NOTICE OF DECISION

SITE PLAN REVIEW / ADJUSTMENT CASE NO. SPR-ADJ16-06

LOCATION: 1177 Center St NE / 97301

**SITE PLAN REVIEW / ADJUSTMENT CASE NO. SPR-ADJ 16-06
DECISION**

PROPOSED LANDSCAPE PLAN

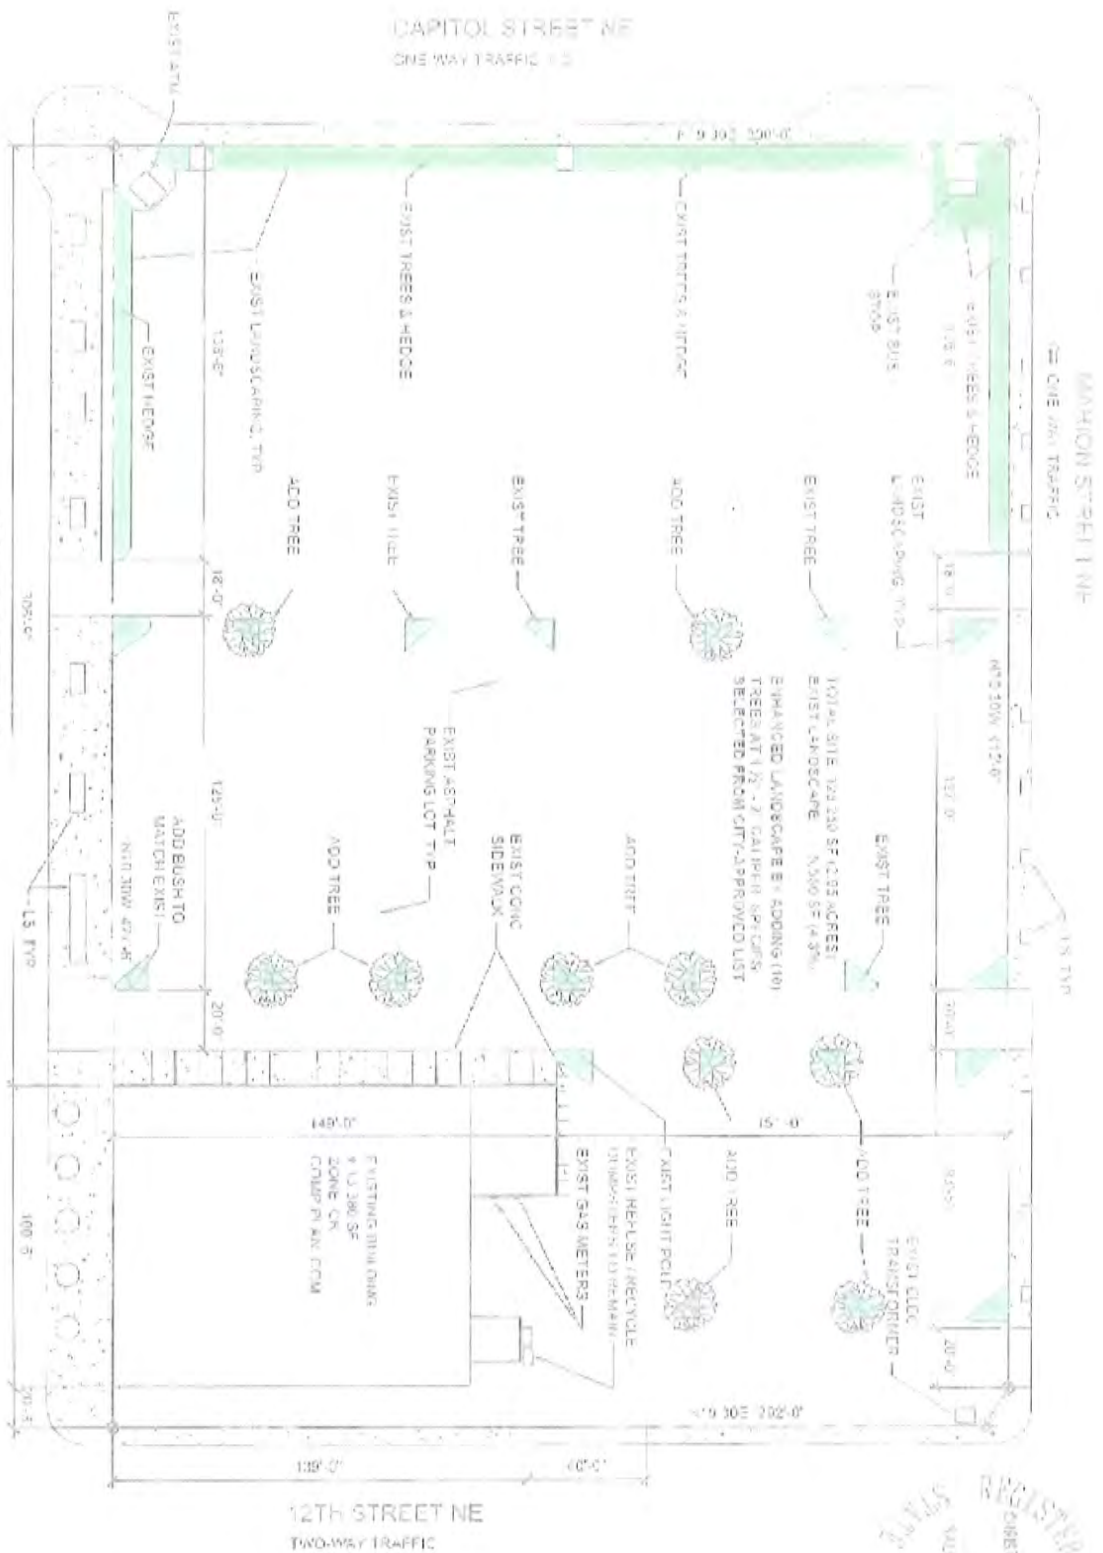
Staff Response: The applicant's site plan does not indicate bicycle parking. To ensure compliance with this standard, the following condition is necessary:

The purpose of landscaping is to improve the appearance and visual character of the community. The applicant is not proposing any additional landscaped area on site. Based on the affected site area, 192 square feet ($19,169 \times 1\% = 191.69$) of landscaped area would be proportional to the affected area. When reviewing the current location of landscaped area, it would appear that there is no landscaped area along 12th St NE to provide an attractive appearance. Therefore, to meet the intent of landscaping requirements and be proportional to the proposed development, 192 square feet should be added to the property along 12th street.

The intent of interior landscaping is to create a canopy effect and to break up expanses of paving and long rows of parking spaces. Trees for interior landscaping are to be deciduous shade trees. The proposed landscaping plan does not indicate the type of trees.

Condition 1: A bicycle rack to accommodate 2 bicycle spaces shall be provided.

Condition 2: A minimum of 192 square feet of landscaping area meeting the Type A landscaping standards shall be provided along the 12th St NE frontage.

Condition 3: Landscaping shall be provided as indicated in the Landscaping Plan.

Condition 4: New trees indicated on the Landscaping Plan shall be deciduous shade trees.
